Computer Monitors Service Bulletin

Model: GDM17SE1 No. 76

Subject: Countermeasure for High Pitch Squeal **Date:** January 9, 1995

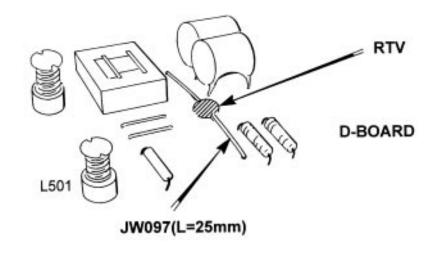
(154) A high frequency squeal is audible when using the MAC 16" Mode

Solution: The noise comes from JW097 (jumper wire). JW097 vibrates due to L501 (Horizontal

Linearity Coil). To confirm the noise source, touch the center of JW097 using a

If the Noise is confirmed, apply RTV in the middle of the jumper wire as illustrated

below:

JW097 is located in the middle of the D-Board near L501 and T502.
